PROPOSED NEW ACCESS TRACK , OXENRIGGS FARM 4/24/2296/0F1

In response to the comments from Highways, we would like to respond as follows (Highway comment in black and our response in blue)

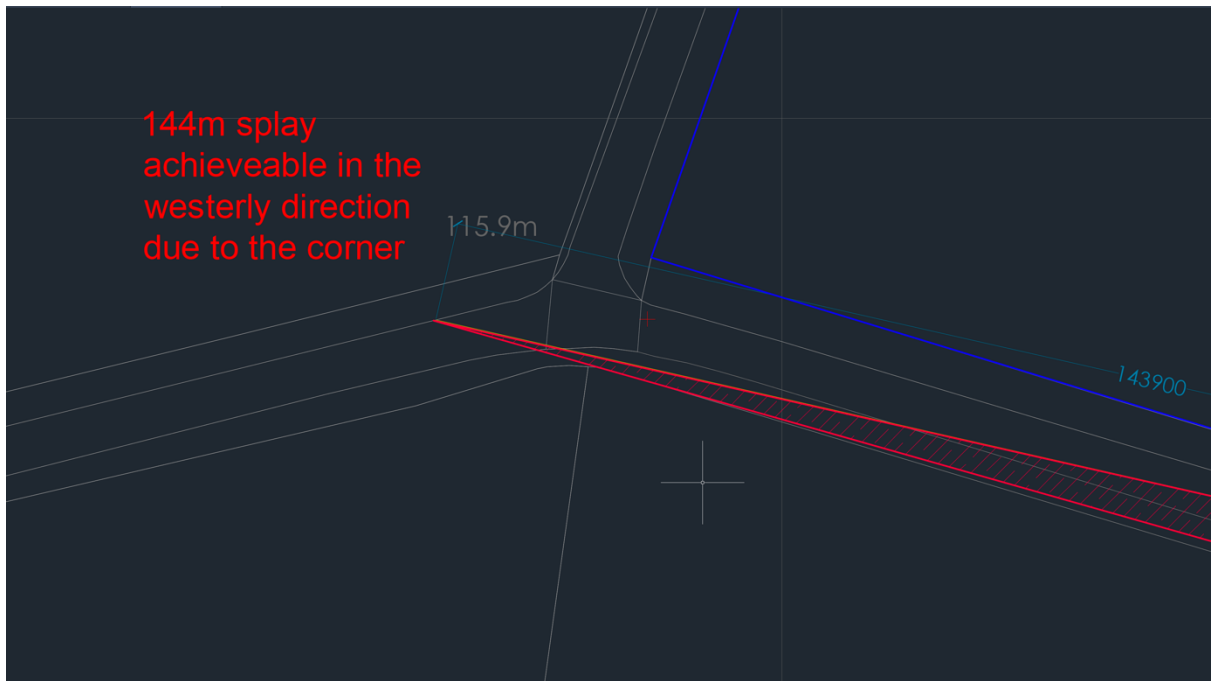
3. The Visibility splay lines would appear to cross over into the hedge(which is not shown on the visibility splay diagram) and there is no indication that the hedge is being removed or relocated. It is worth noting that the LHA will accept an 'x' value of 2.0m for a single dwelling access and this may help. Incidentally, the existing access on the outside of a corner is ideally placed to avoid this problem of emerging from a hedgerow on a straight road.

Splays reduced to 2m back, however due to the width of the verges on the same and opposite side, we don't believe that the junction is obscured by any hedging due to wide verge. See Zoomed in image below.
